**SPECIAL PLANNING COMMISSION MEETING
Wednesday, December 03, 2025 at 5:00 PM**

GMS, Inc. has reviewed the drawing set submitted by the applicant for the proposed Highbrook Subdivision project. The documents reviewed are as follows.

1. Site Plan Drawing Sheet 1 of 2 – The Overlook at Palmer Lake, prepared by Crossed Paths Surveying Services, Inc., date of latest revision of August 13, 2025.

1. Site Plan Drawing Sheet 1 of 2 – The Overlook at Palmer Lake, prepared by Crossed Paths Surveying Services, Inc., date of latest revision of August 13, 2025.

drawing date: June 29, 2025
 scale: 1" = 20'
 drawn by: JPB
 sheet 4 of 4

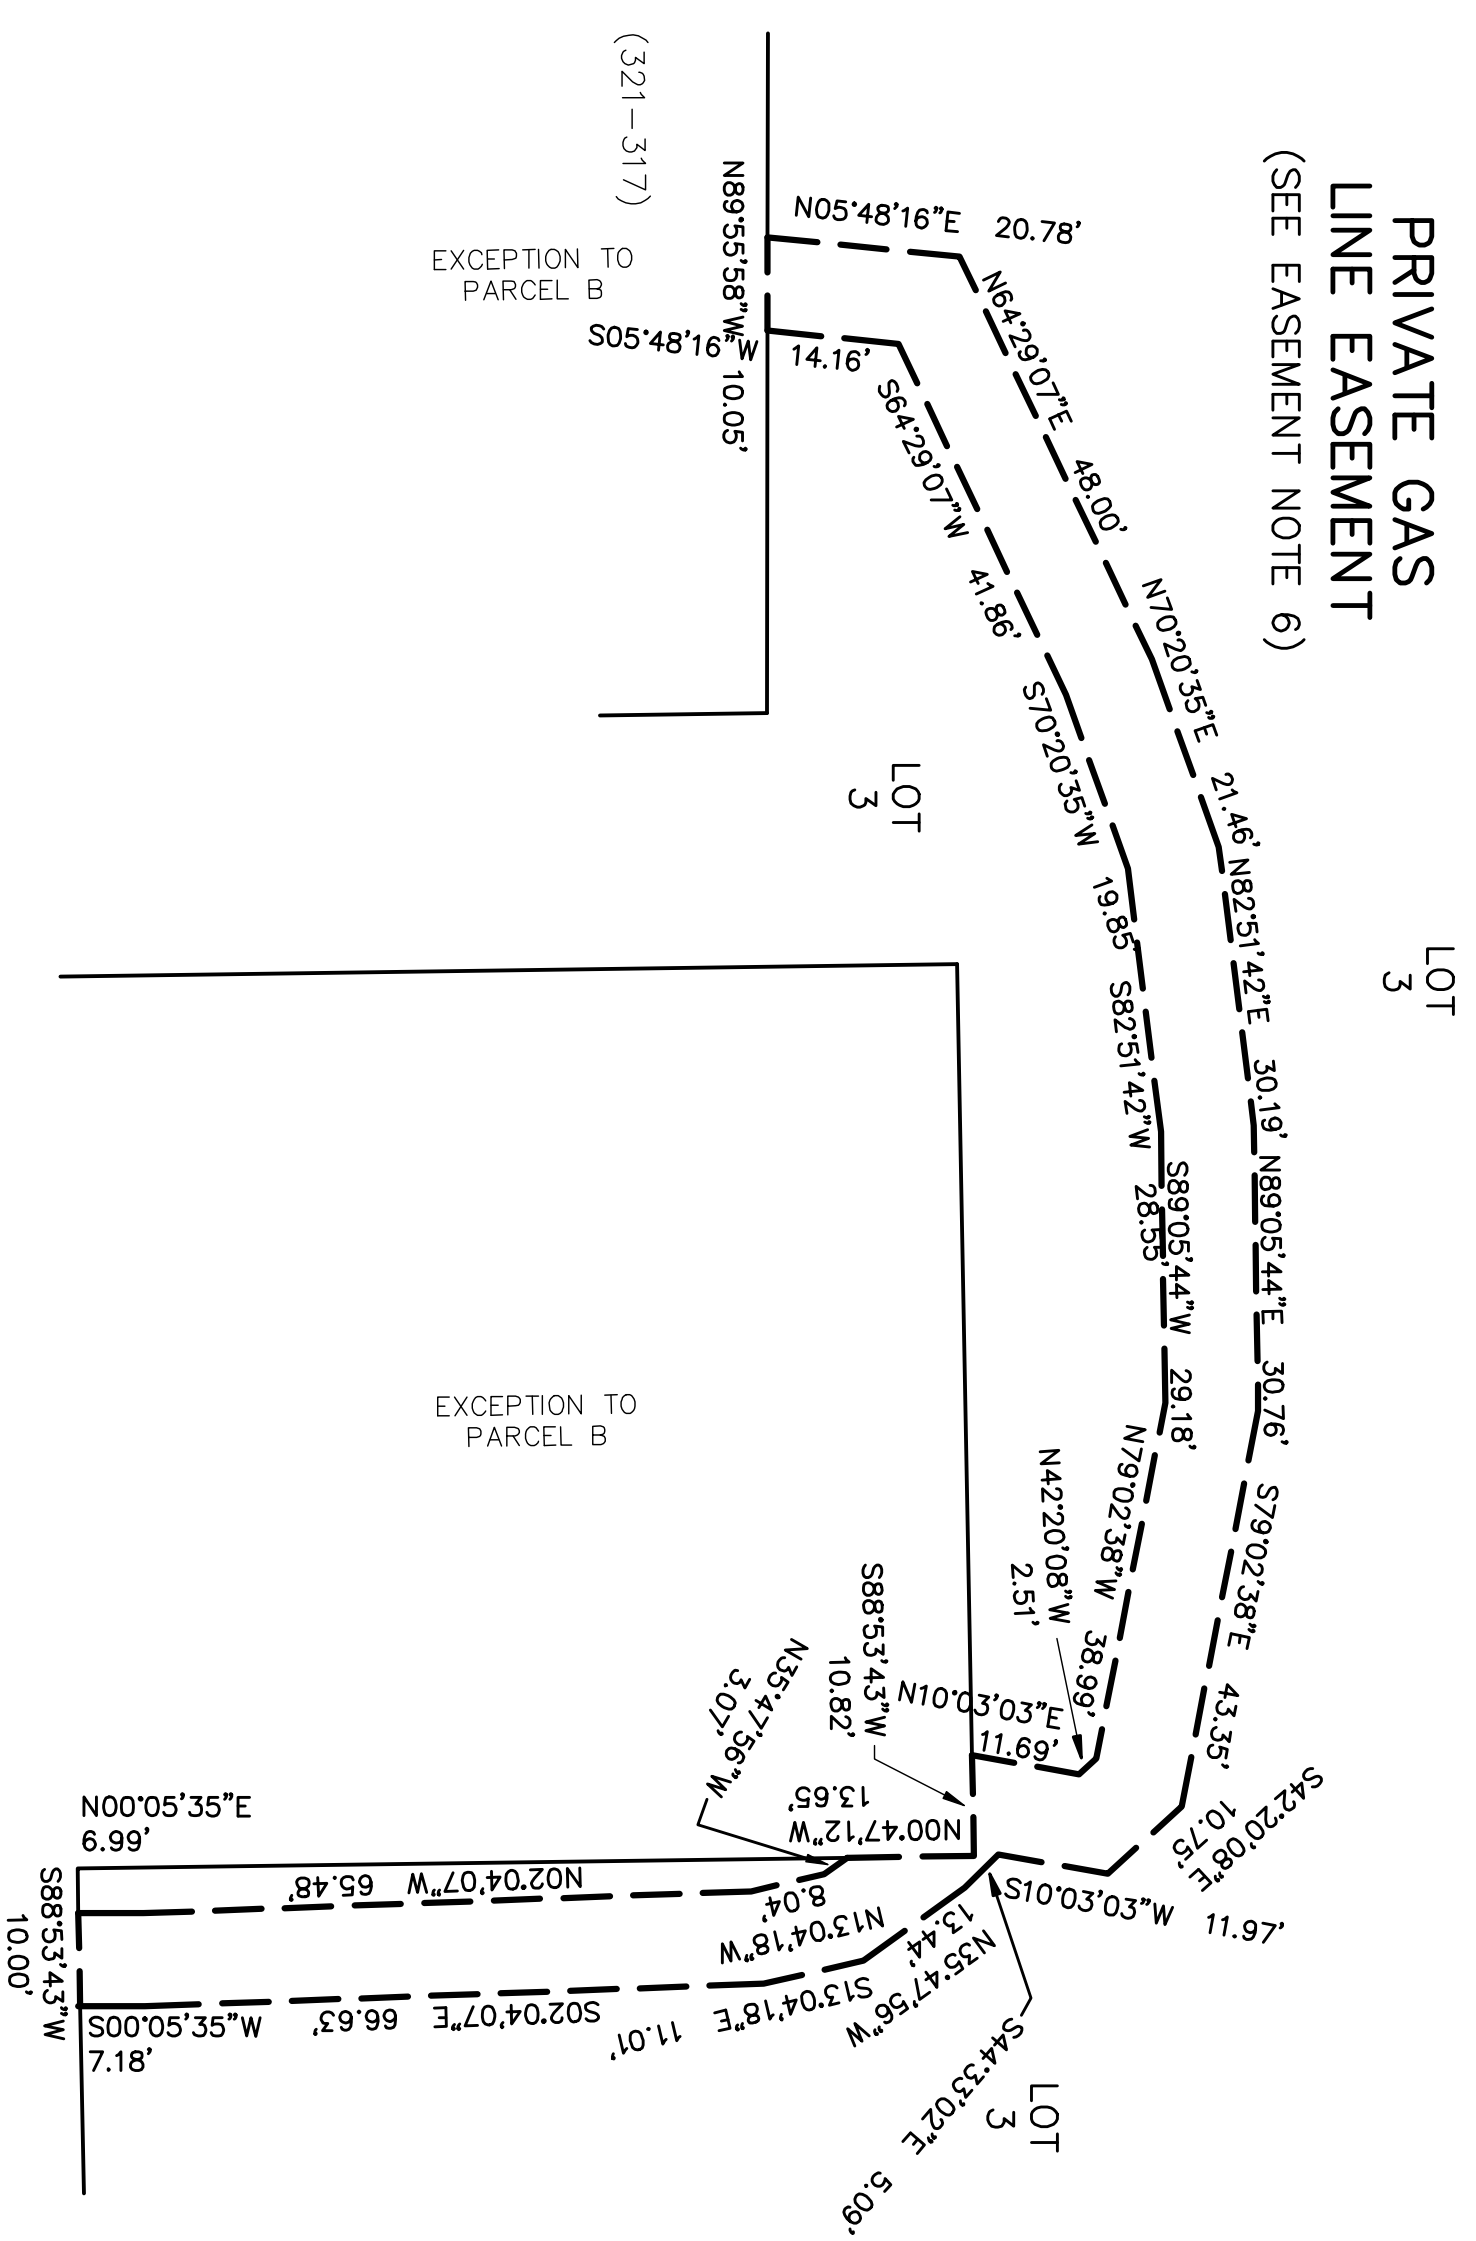
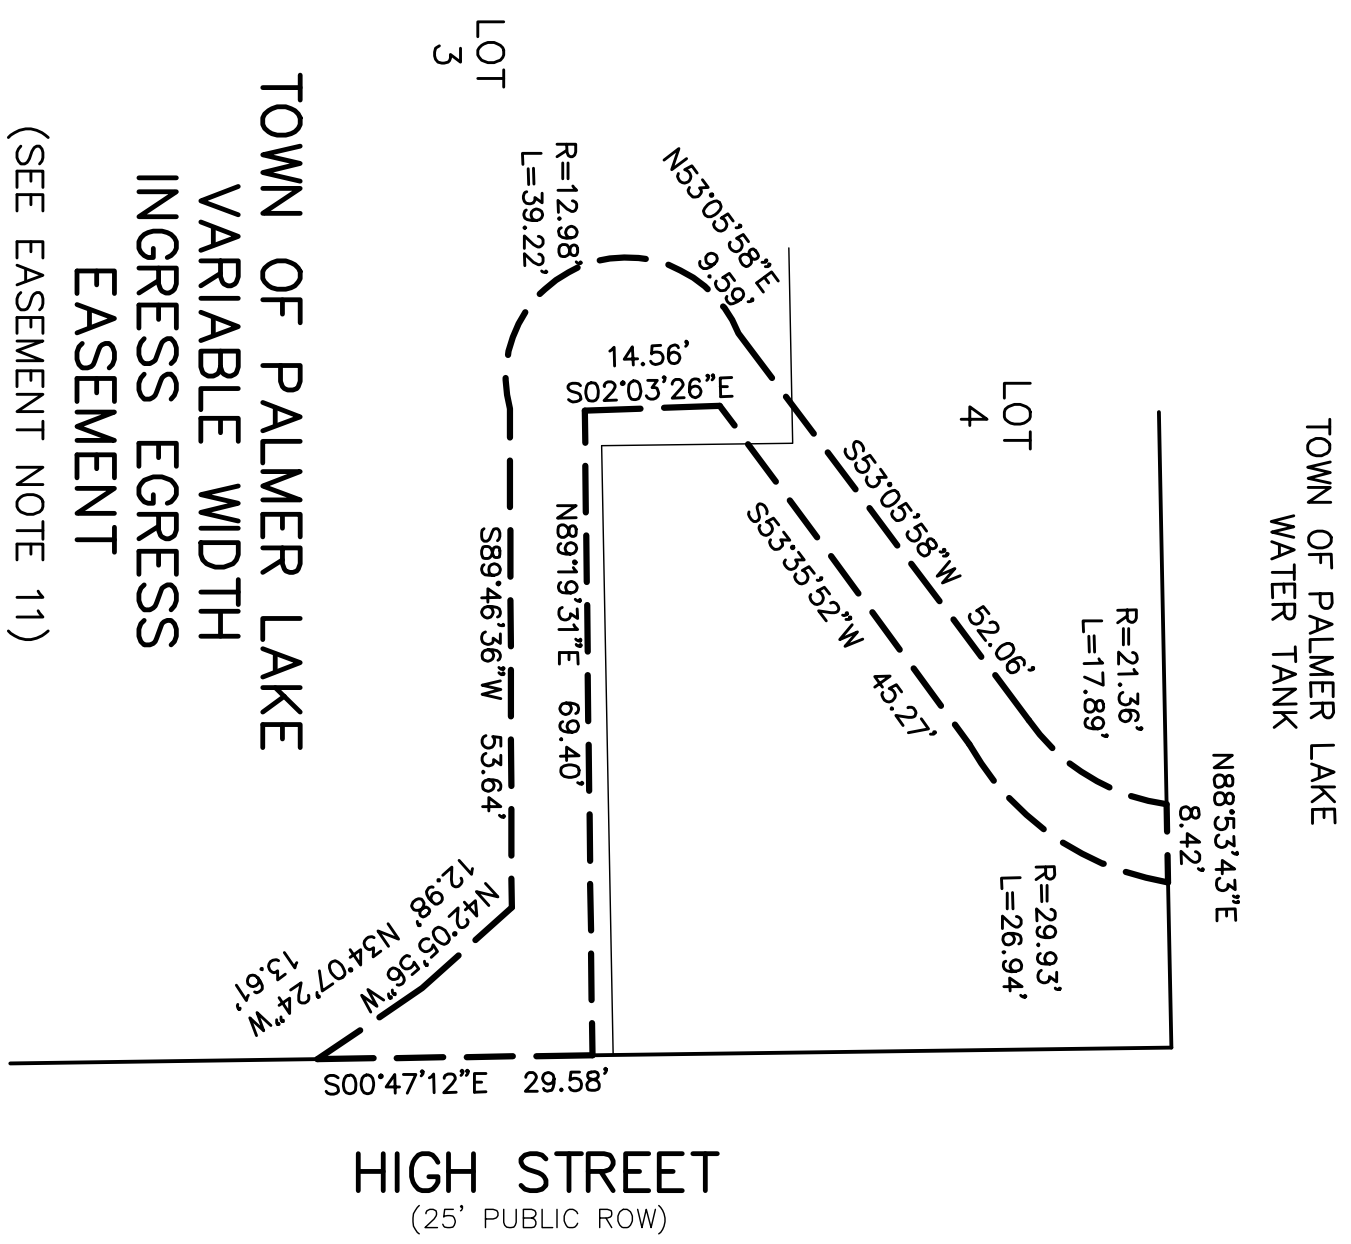
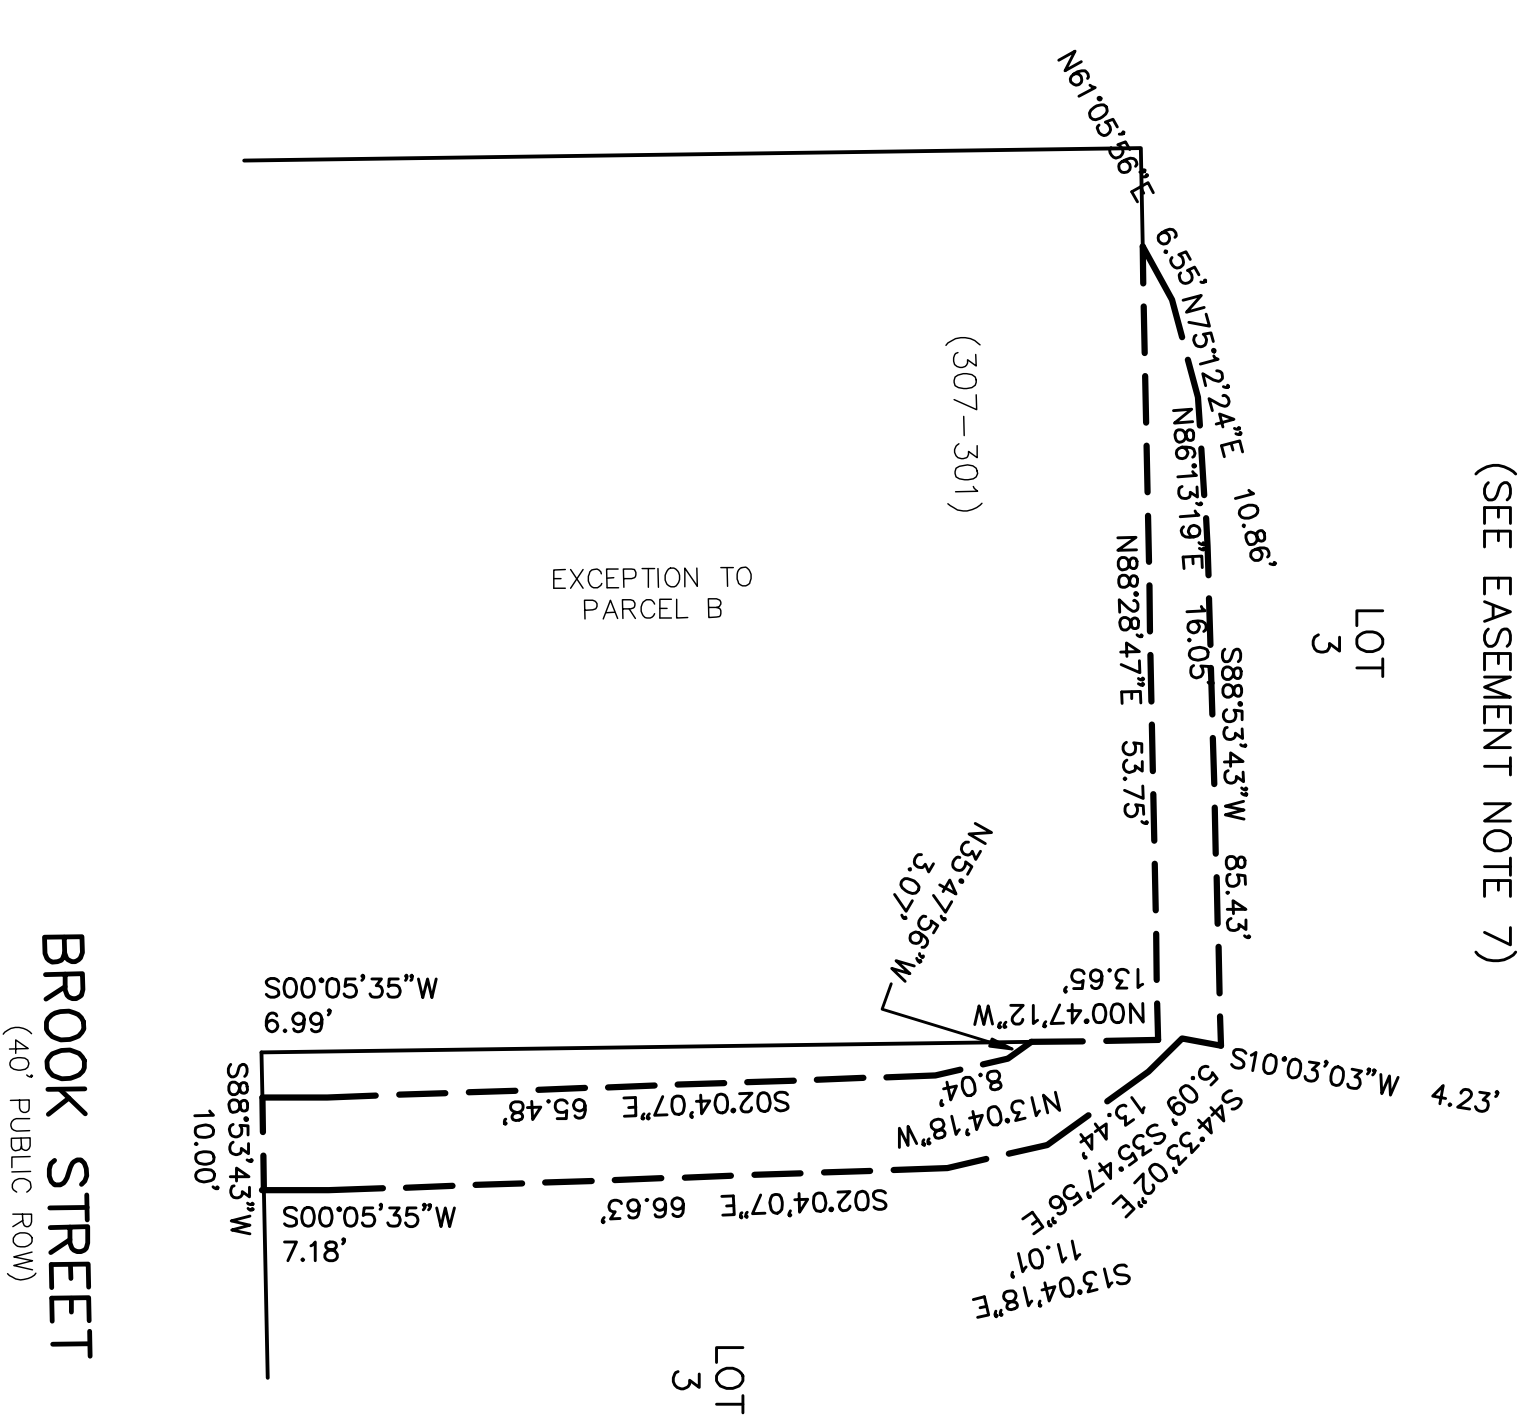
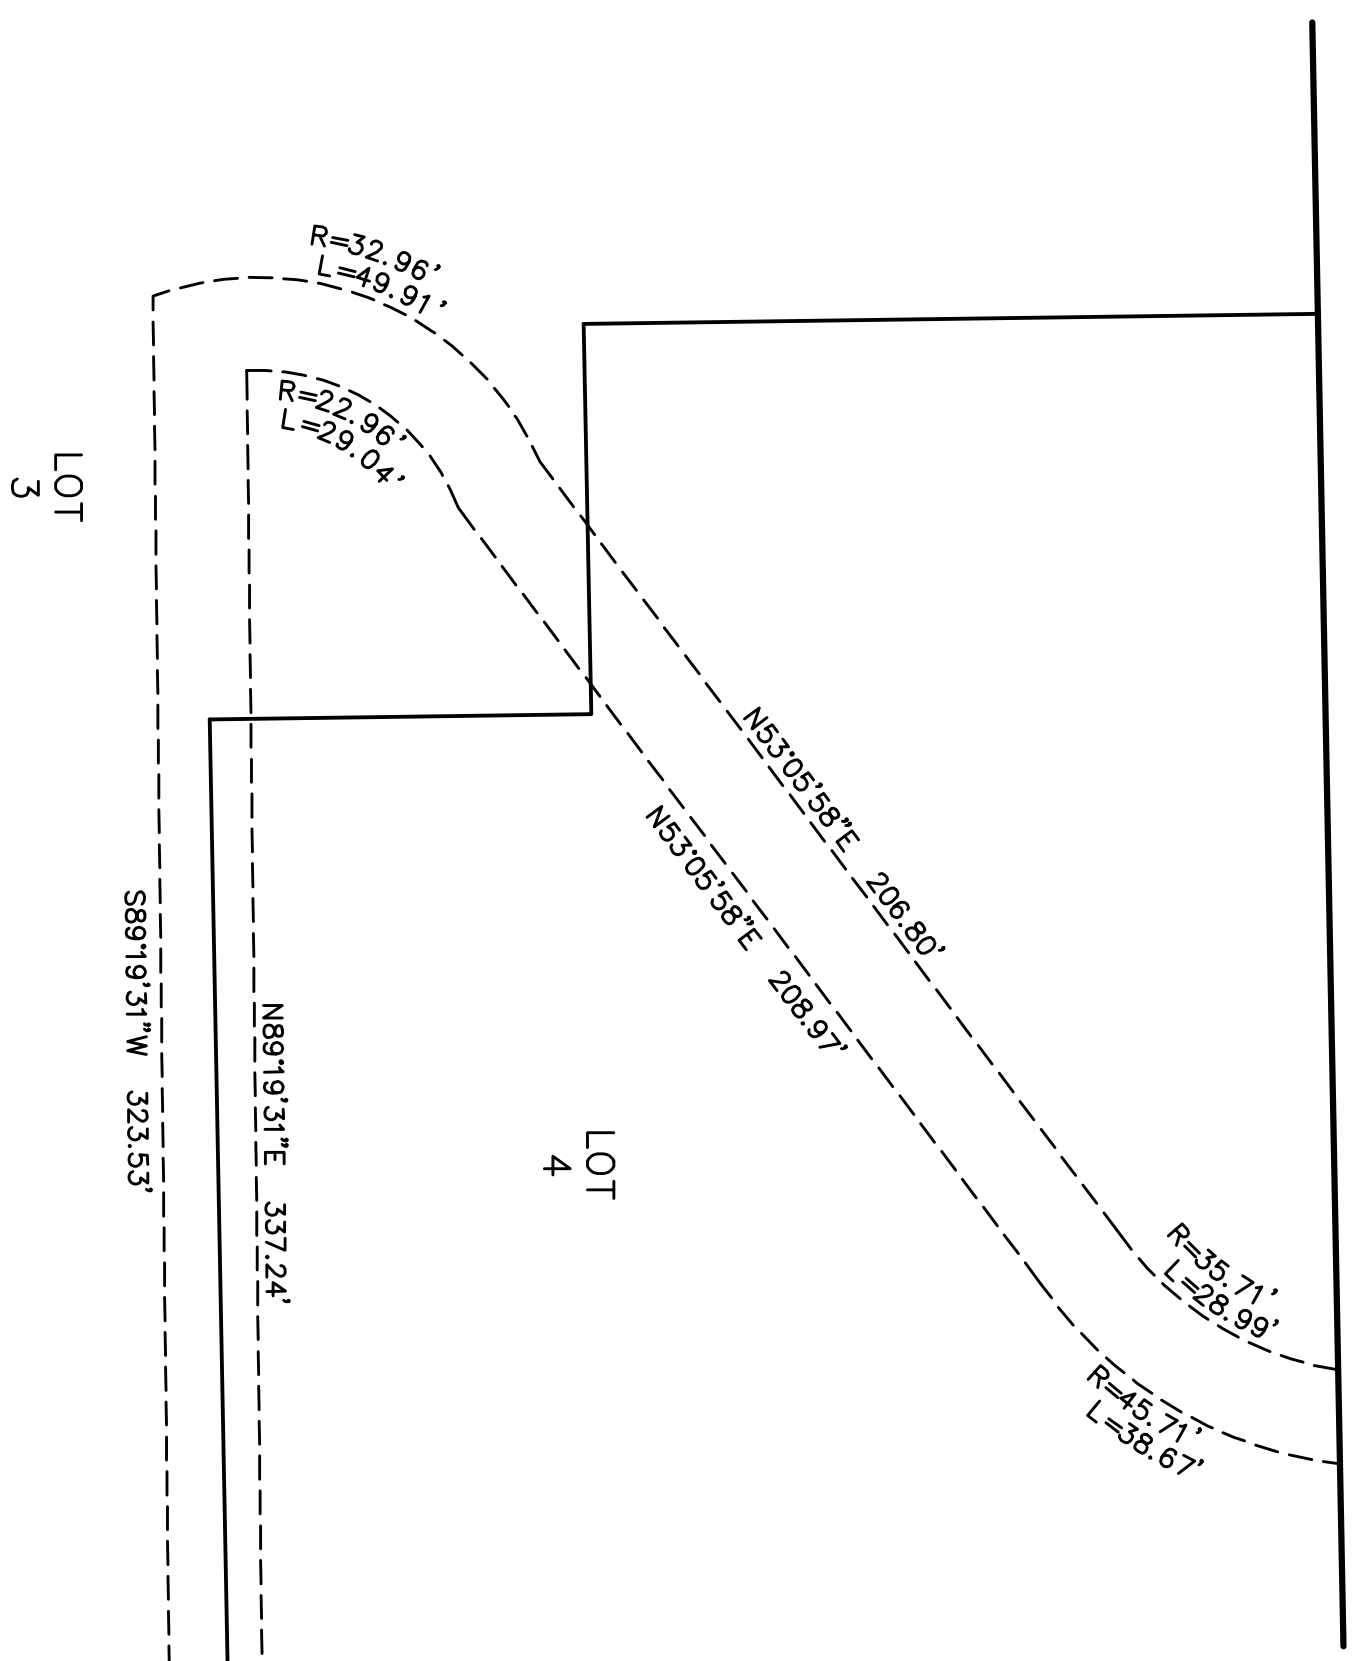
1. Please revise the drawing titles and all references to the project name to state the correct name of Highbrook Subdivision. In accordance with Town Code requirements, resubdivisions shall continue with the previous subdivision name rather than changing the name as presented on the submittal drawings.

- c. The maintenance responsibilities listed in Easement Note #9 must be removed as that information will be specifically defined in the easement agreement documents along with the access priority being with the Town to access the water tank site. Please revise accordingly.

8. Regarding the Private Variable Width Water Drainage Easement referenced to Easement Note 11, please address the following comments:
 - a. It is recommended that the easement be referenced as a Water Drain Pipe easement rather than a Water Drainage easement to avoid confusion in its purpose. Please revise accordingly

- b. As the proposed easement is intended to be dedicated to the Town of Palmer Lake, it is recommended that the easement be noted as a Town of Palmer Lake easement, not a private easement as indicated on the drawings. Please revise accordingly.

- 1. Please revise the drawing titles and all references to the project name to state the correct name of Highbrook Subdivision. In accordance with Town Code requirements, resubdivisions shall continue with the previous subdivision name rather than changing the name as presented on the submittal drawings.

- easement boundary with dimensions from the edge of road to the easement boundary.
- c. The maintenance responsibilities listed in Easement Note #9 must be removed as that information will be specifically defined in the easement agreement documents along with the access priority being with the Town to access the water tank site. Please revise accordingly.

8. Regarding the Private Variable Width Water Drainage Easement referenced to Easement Note 11, please address the following comments:
- a. It is recommended that the easement be referenced as a Water Drain Pipe easement rather than a Water Drainage easement to avoid confusion in its purpose. Please revise accordingly

- b. As the proposed easement is intended to be dedicated to the Town of Palmer Lake, it is recommended that the easement be noted as a Town of Palmer Lake easement, not a private easement as indicated on the drawings. Please revise accordingly.

- G. Plat Drawing Sheet 4 of 4 – As this drawing details multiple individual easements, some of which are proposed for the Town of Palmer Lake, additional coordination on the preparation, execution and recording of these individual easement documents will be required. Refer to reply for comment A.1. above.
